ADDENDUM NO. 1 – RFP FY26-CCO-01
NORFOLK INTERNATIONAL AIRPORT
FOOD, BEVERAGE, RETAIL AND VENDING CONCESSION PROGRAM
Issued: July 1, 2025

The following questions and requests for clarification were received prior to the stated deadline. The Norfolk Airport Authority ("Authority") offers the following responses to the questions and requests for clarifications received and has attached the existing concessions layout at the Norfolk International Airport (ORF).

1 Level 2- Existing Concession Lease Line Concourse B

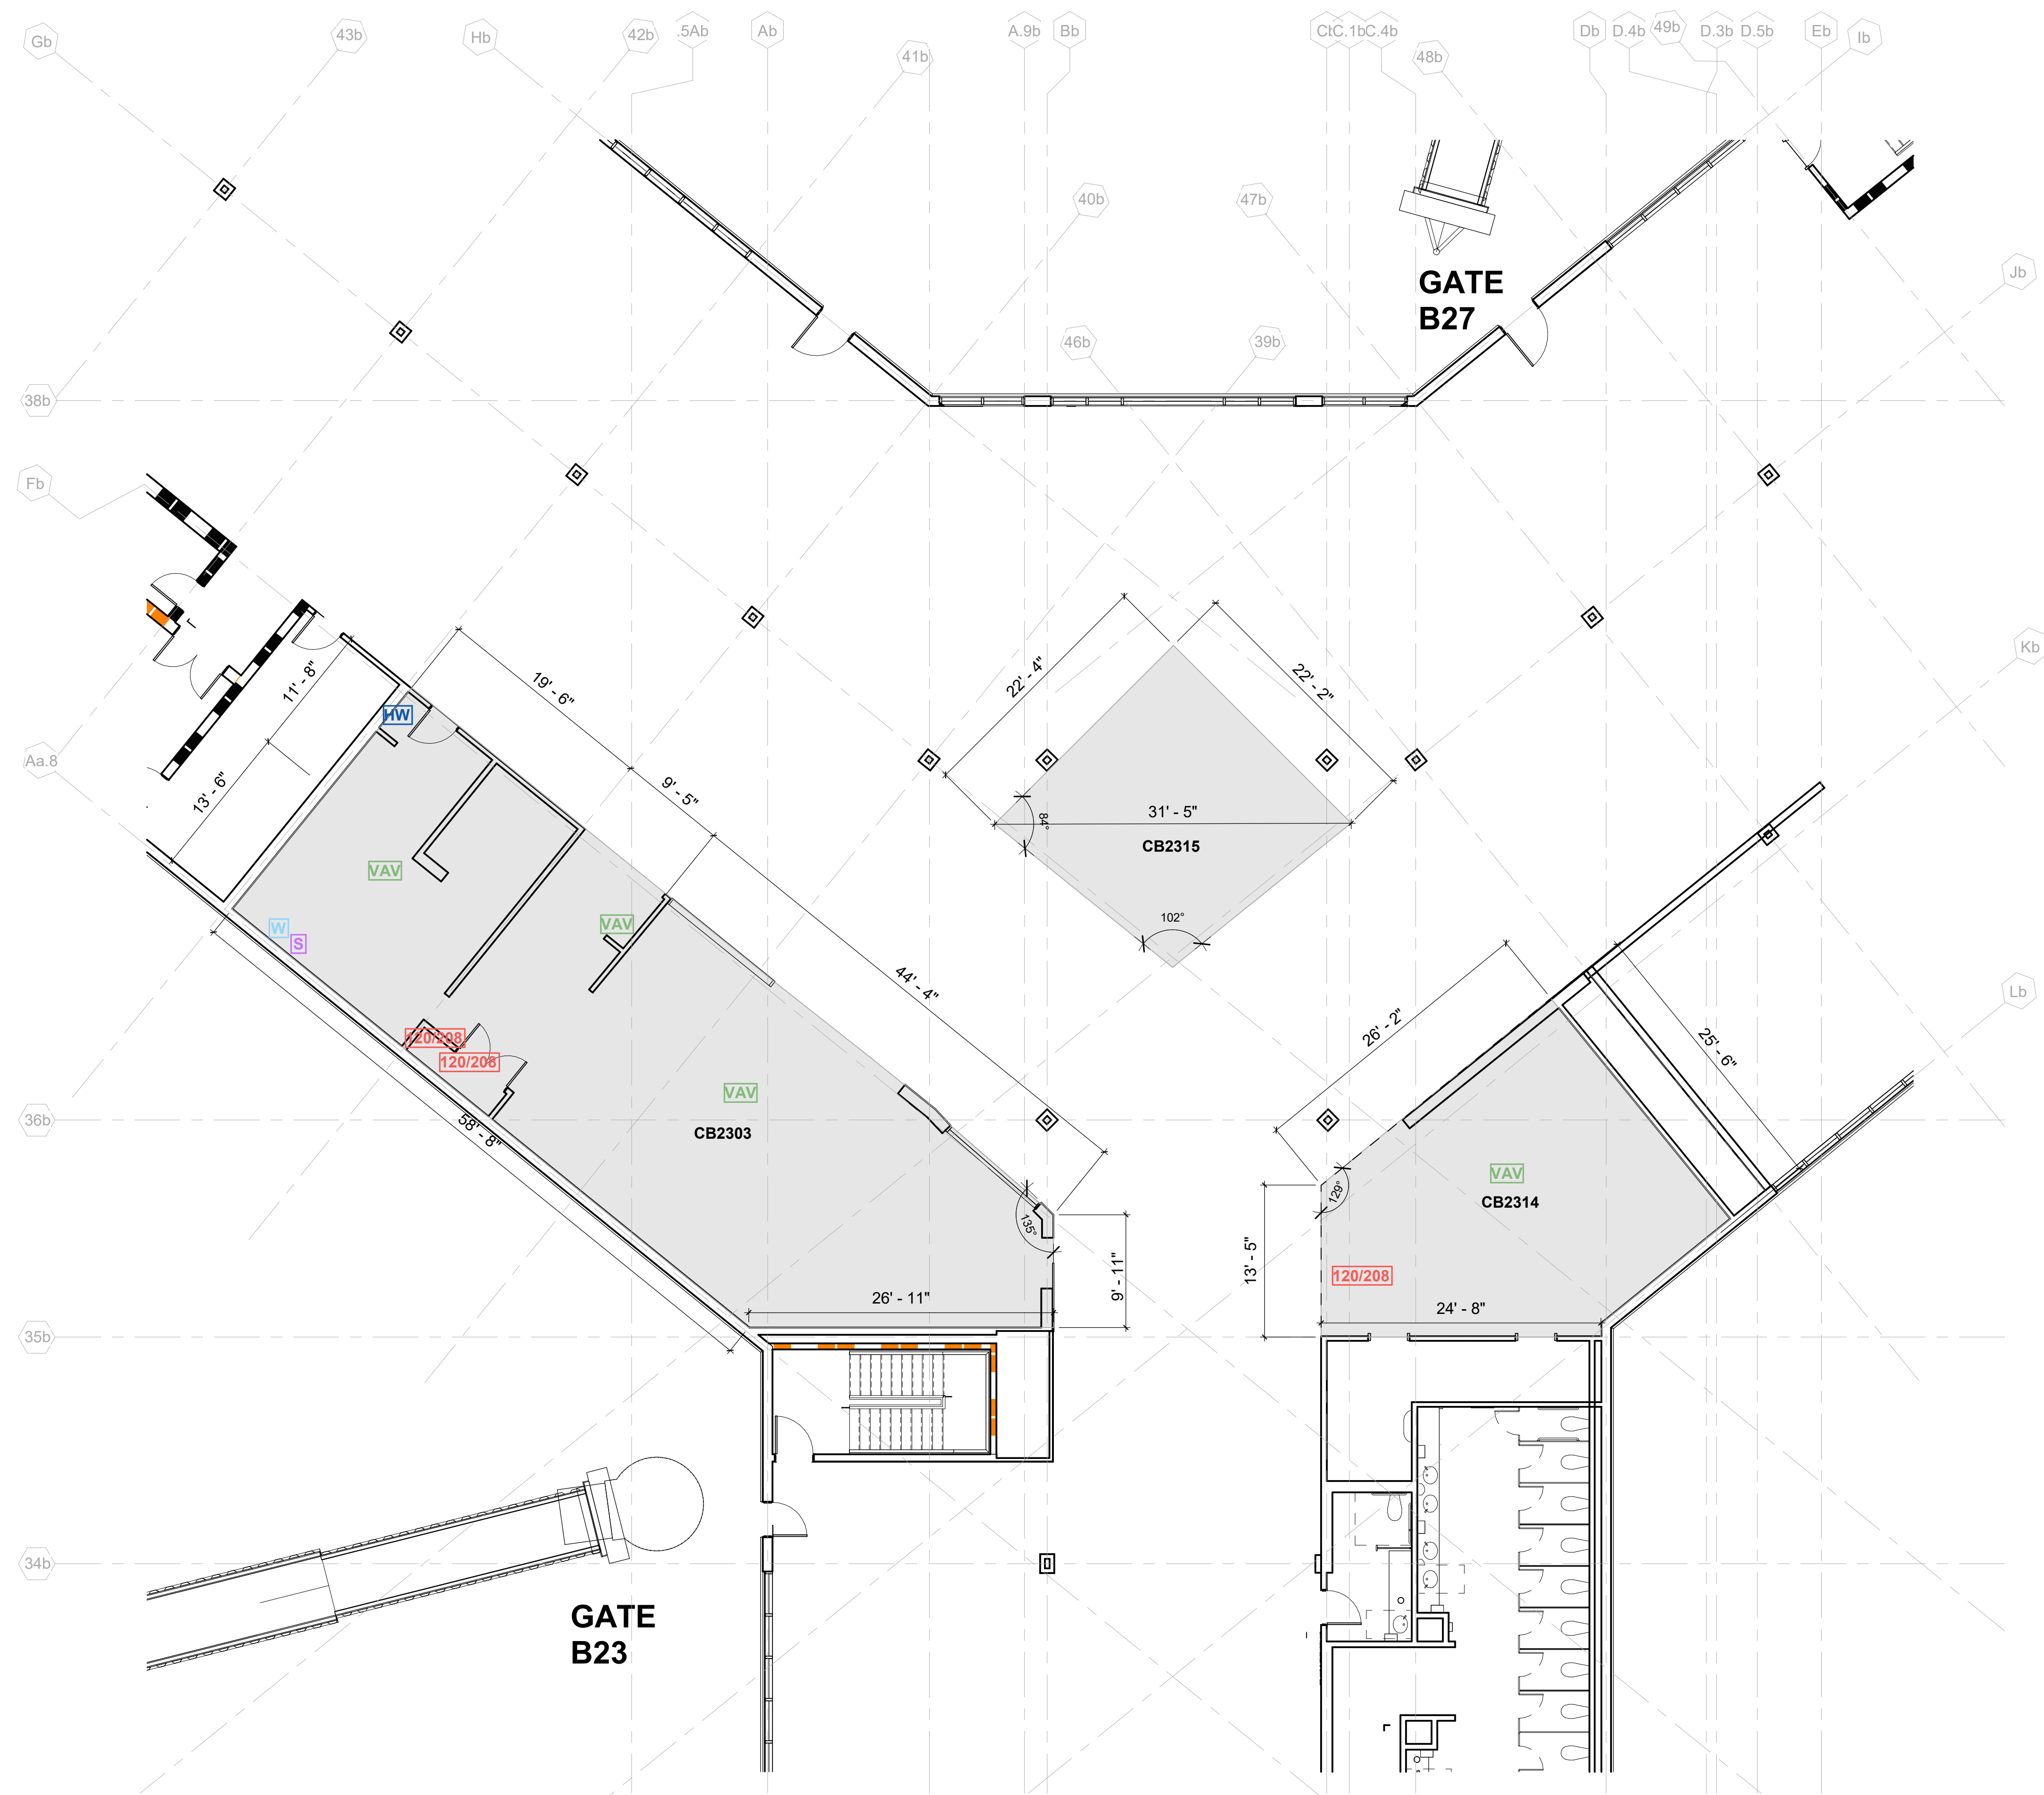
42. Please provide a current lease plan or map detailing the locations of the existing concessions program. **Response:** Attached to this Addendum No. 1 is the existing concessions program locations.
